SEWAGE DISPOSAL SYSTEM

HOWARD COUNTY HEALTH DEPARTMENT

SUBDIVISION Sobus Farm LOT 14 ROAD 2831 Wynfield Road

To: Avis Corbin
From: Daren B. Altieri
Date: January 30, 1997
Subject: Lot 14, Sobus Farms
2831 Wynfield Road
Building Permit #B00102543

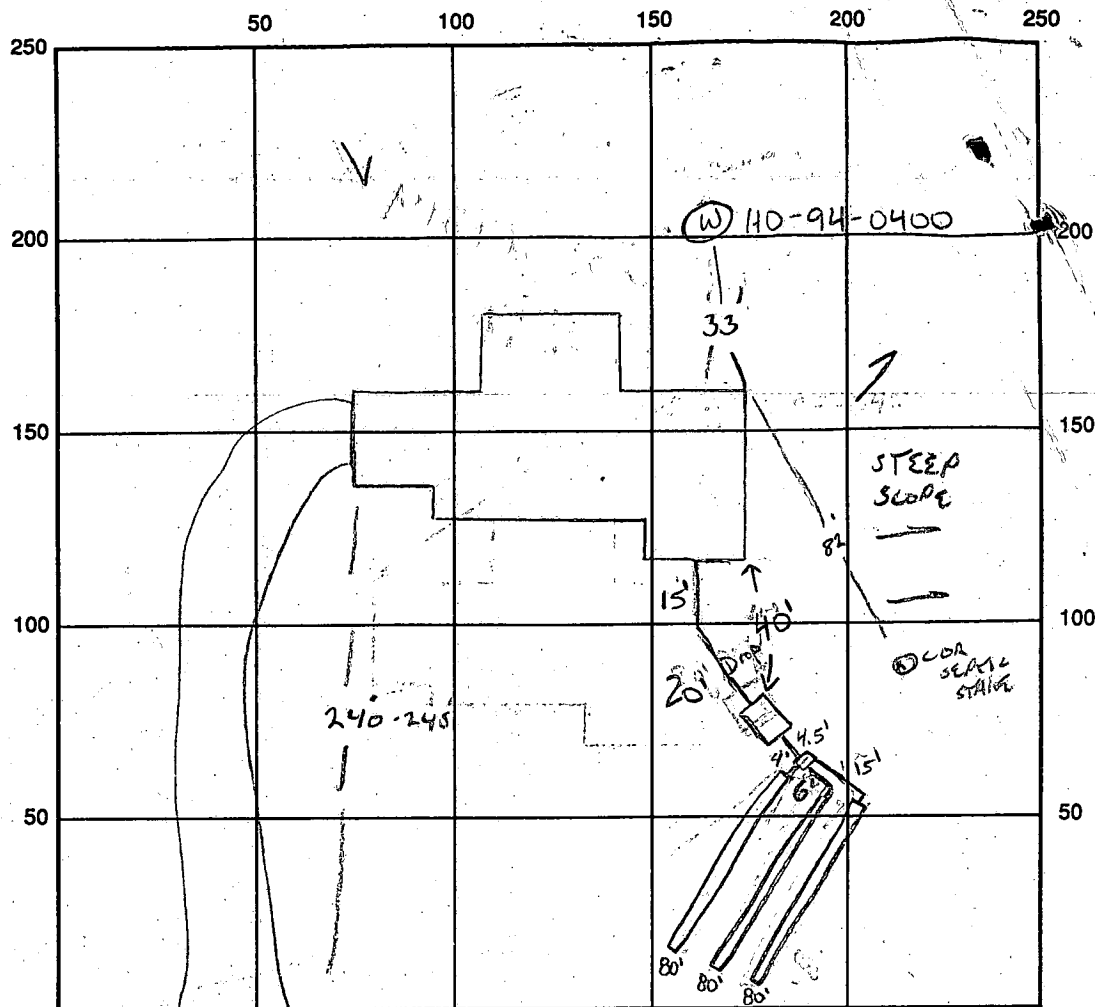
REMARKS: 1-17-97 WDI OK to cover well line KM, House moved BACK FROM PLAN, S.T. TO BE NO CLOSER THAN 100' TO WELL, TRENCH INSTALLATION TO BE AS SPECIFIED - DISCUSSED w/INSTALLER - RAIL (SOUTH CAROL BACKLINE).
1-21-97 house connection made OK to cover up to tank KM
1-24-97 OK to cover all work, needs cleanout on tank, needs pipes connected on distribution box, spoke with septic contractor (LOW) about completing. KM

SEDIMENT and EROSION CONTROL PLAN
1-B AND 10-33
SOBUS FARMS
TAX MAP 15 PARCELS 267134
3rd ELECTION DISTRICT
HOWARD COUNTY, MARYLAND
FOR ALTIERI HOMES INC
3400 GARDENVIEW DRIVE
ELK RIDGE, MD 21227

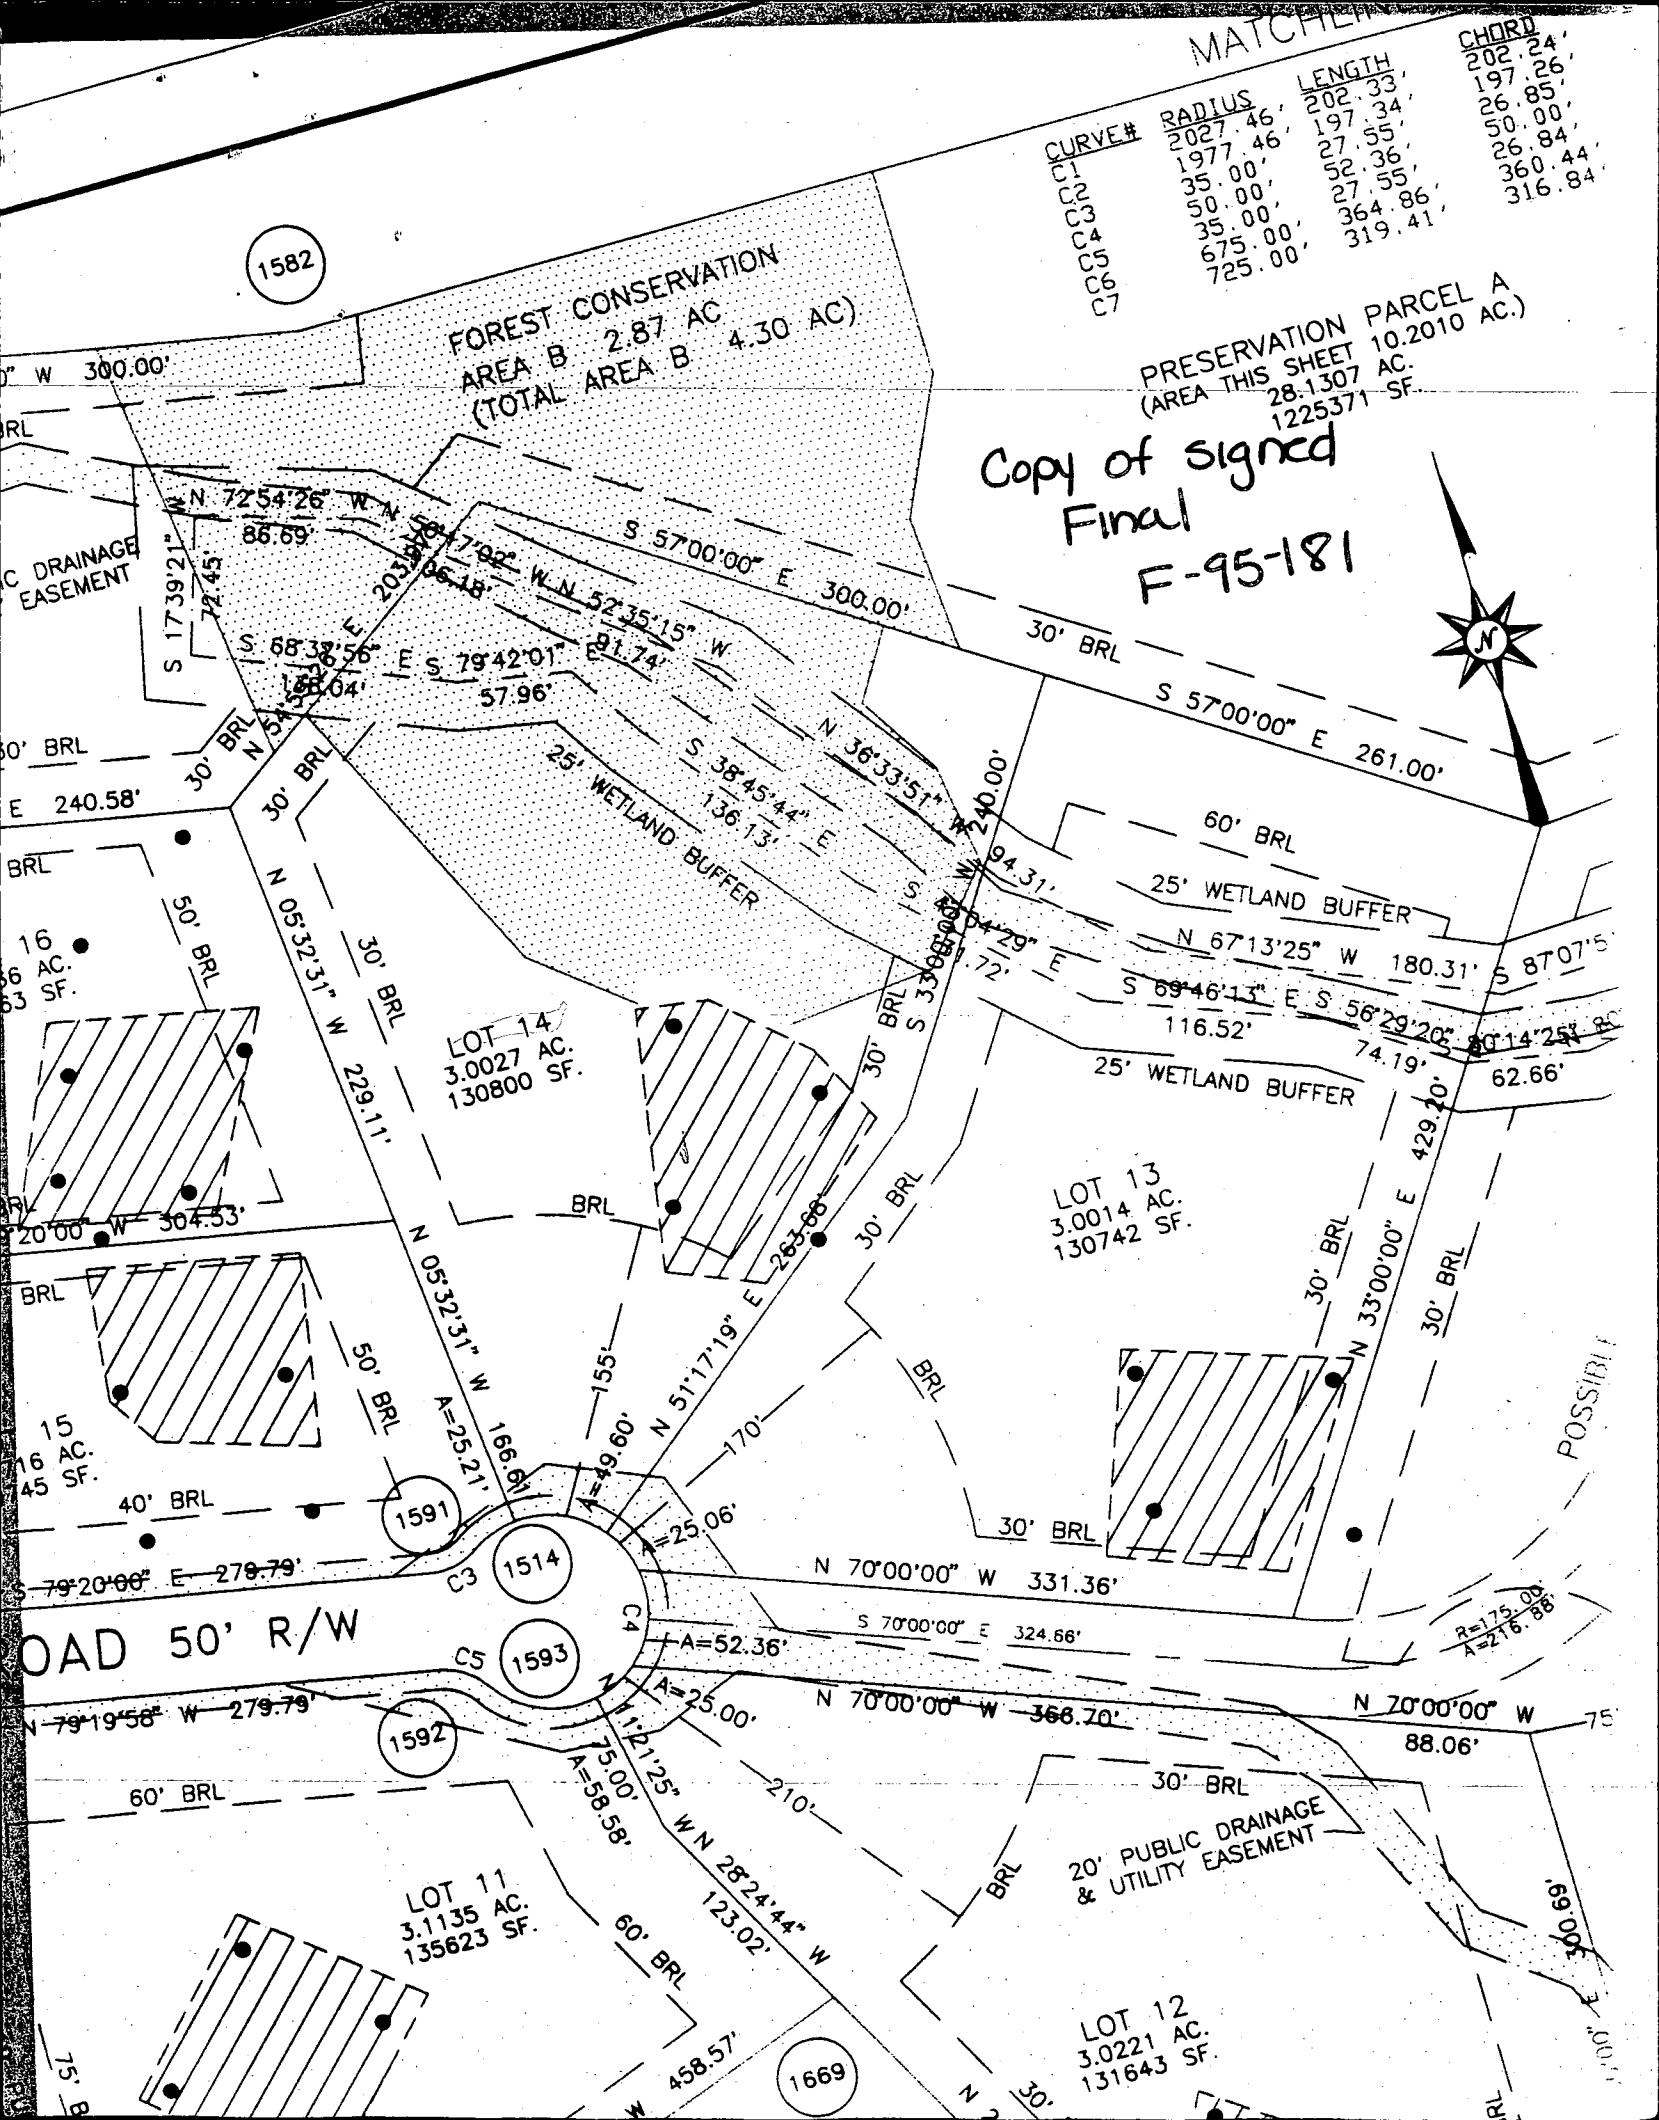
We received a stop work order today on the above mention house because the house was moved back and when they started to put the septic in they noticed the change.

REVISOR
John R. Rutter 2/3/96
Approved Date: 1/30/97
Comments: Relocate
Homer
2831 Skyscraper Rd
#B06102543

2/3/97 Revision OK -
no impact to existing
well or septic.
